**RFB-2022-42**  
**SCCC CHEMISTRY LAB RENOVATION**

**ADDENDUM #2**

Issued Date 3/2/2022

AA-1

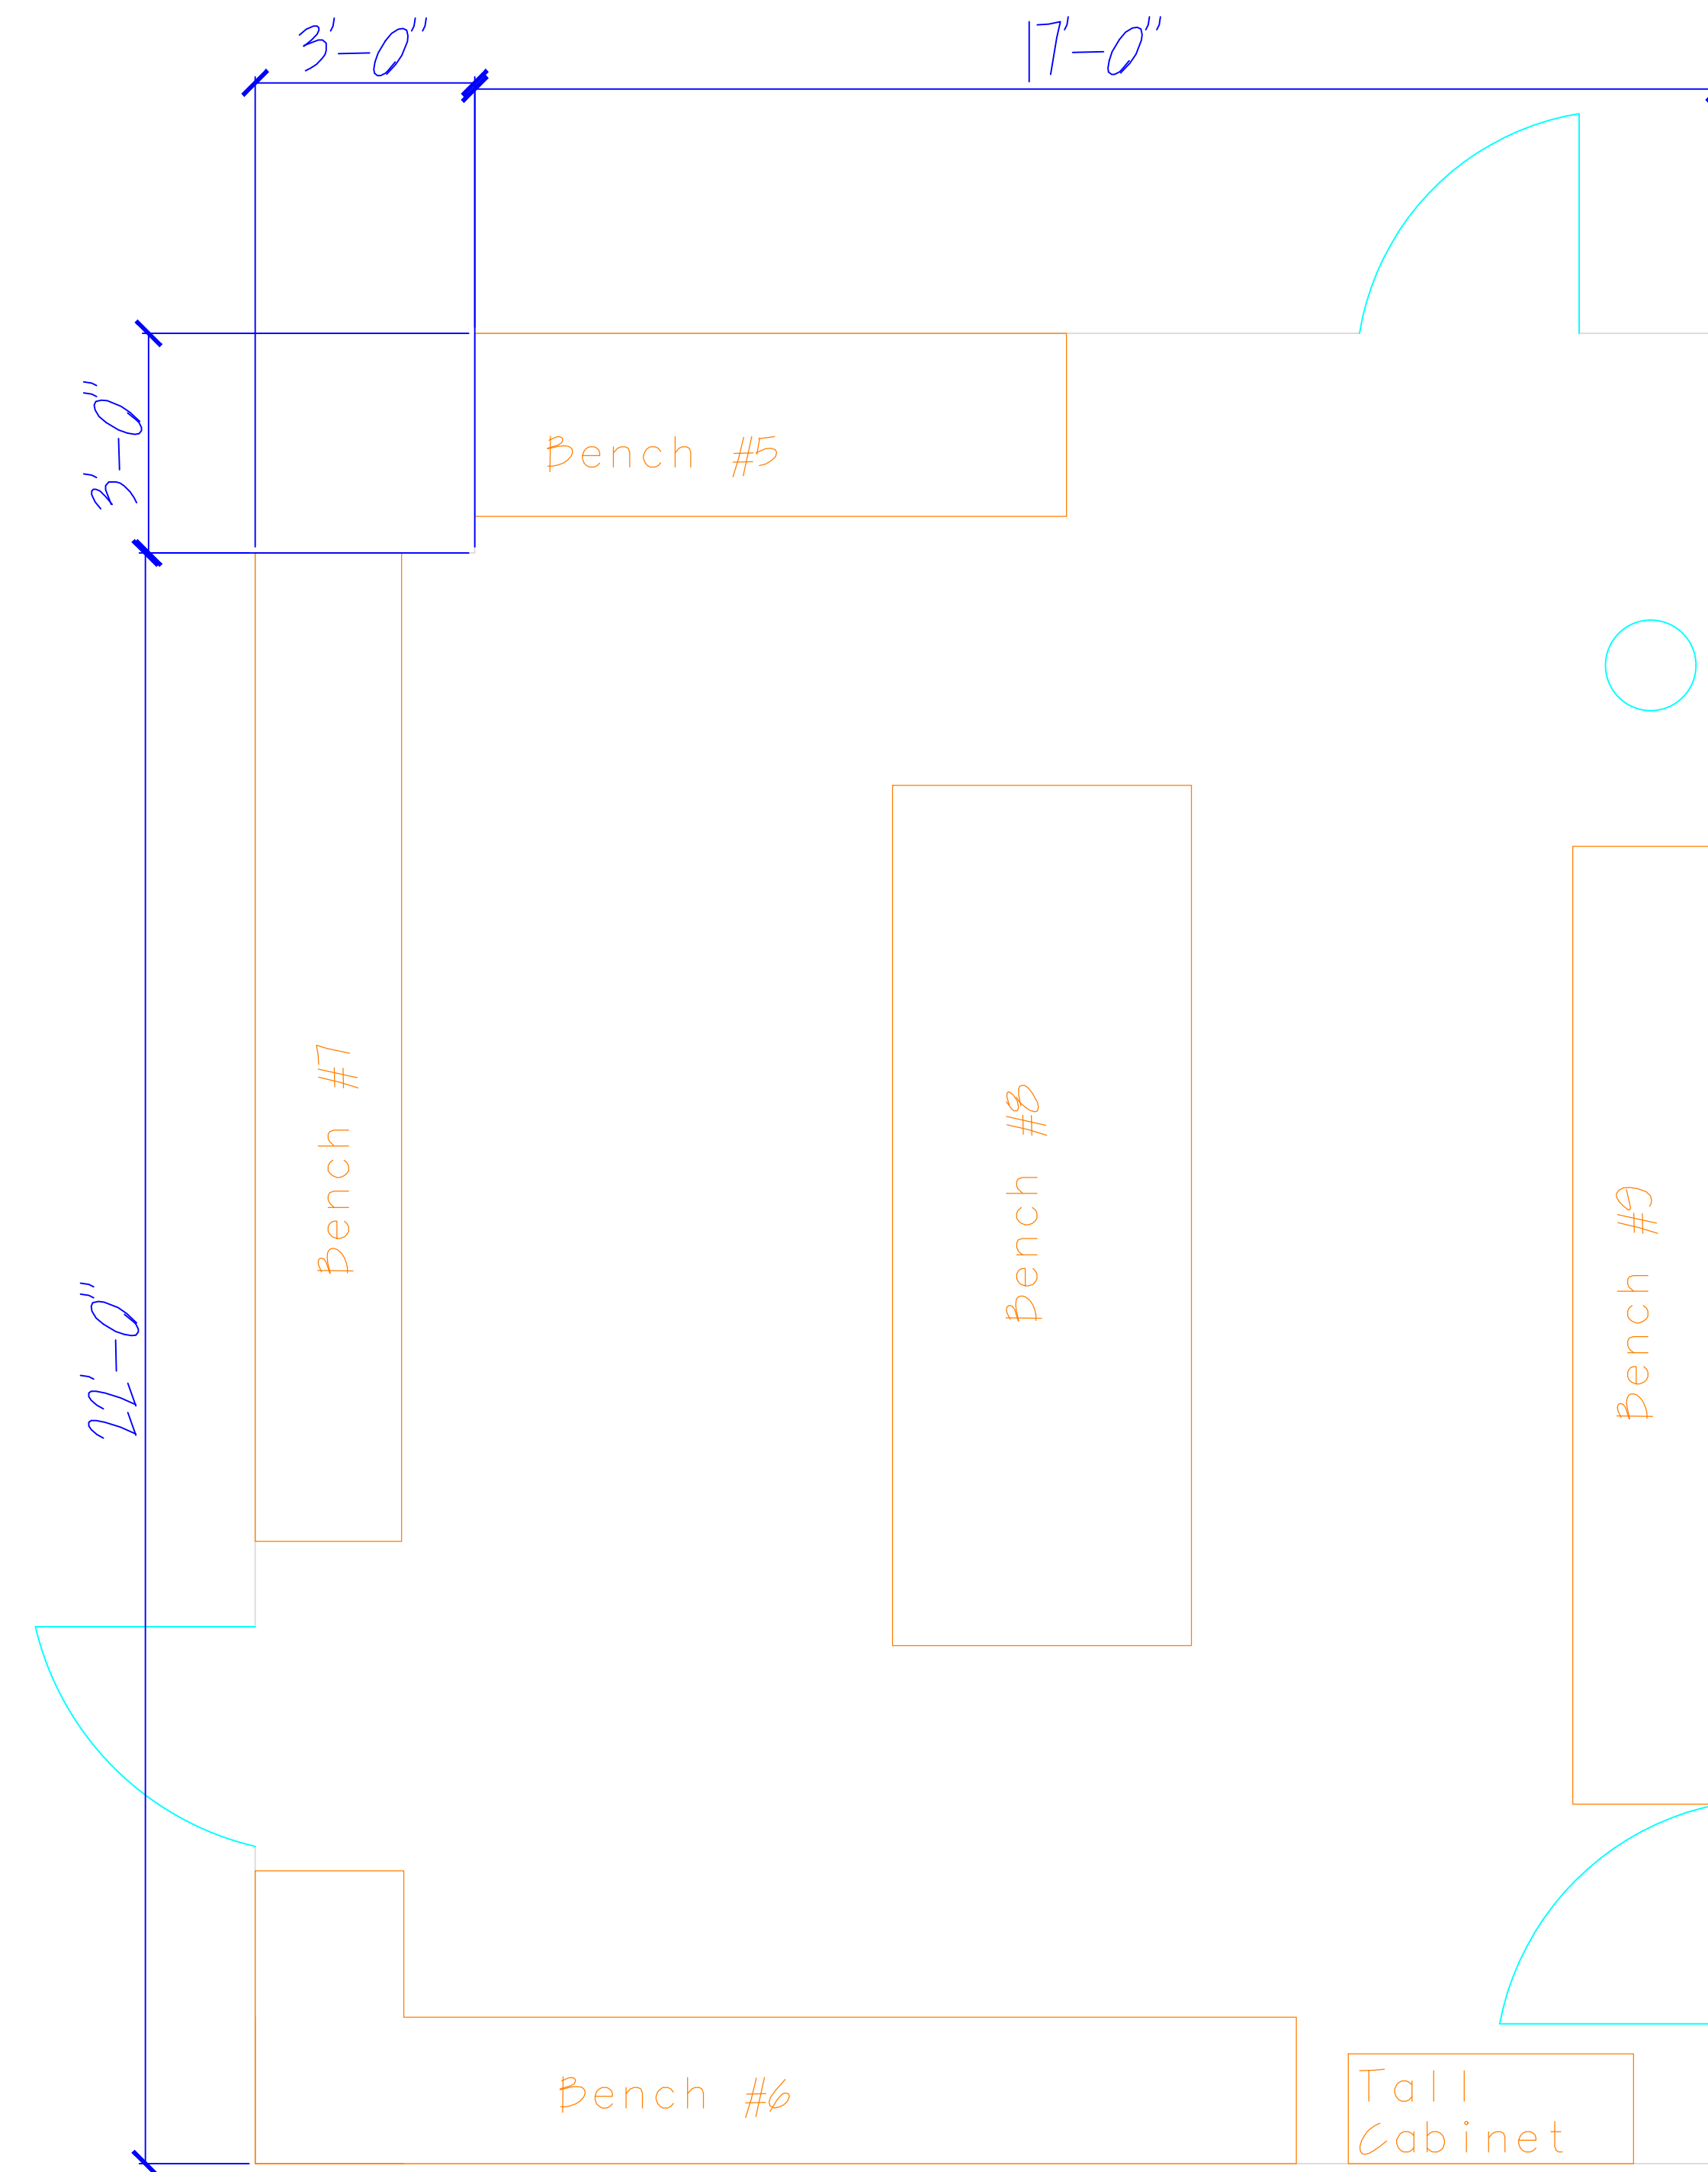
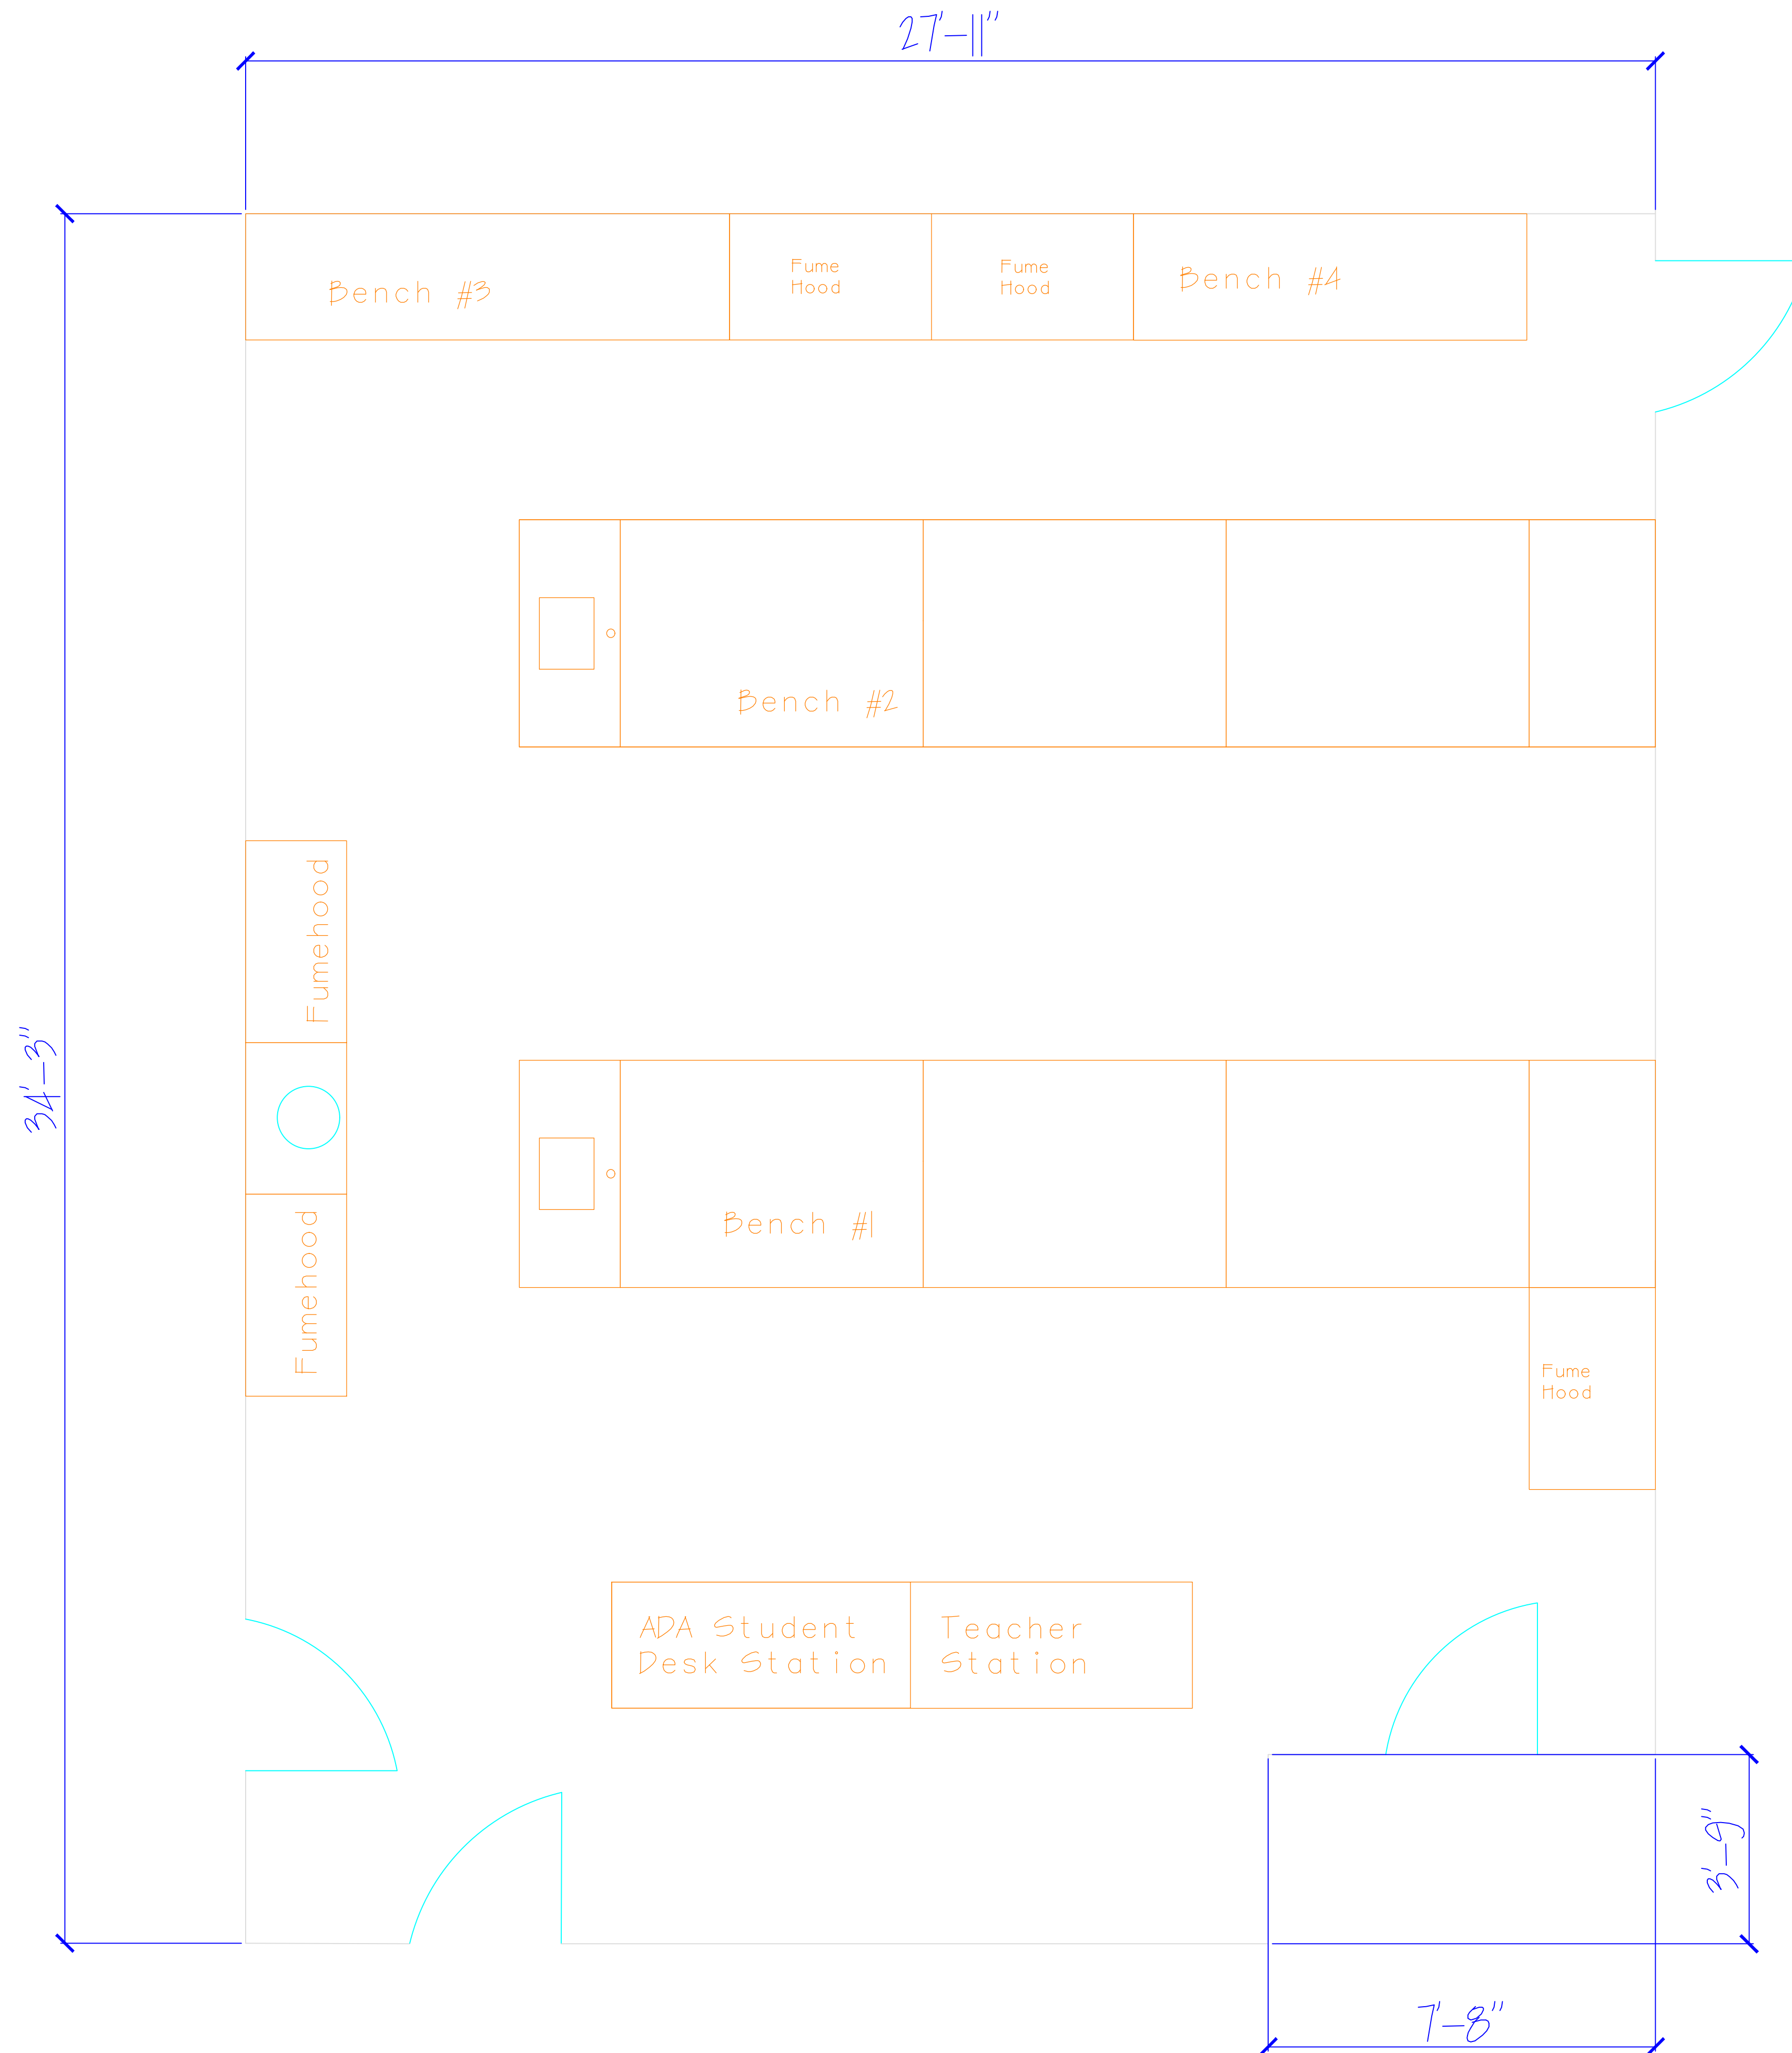
Answer: [Please see revised drawings attached to this addenda.](#)
  11. Can CAD drawings of Chem Lab Room 202 and Prep Room with overall room dimensions be provided?

Answer: [Please see revised drawings attached to this addenda.](#)
  12. Are Fume Hoods to be quoted? And if so, what are specs and dimensions on Fume Hoods shown in the drawings, and how many Fume Hoods are requested?
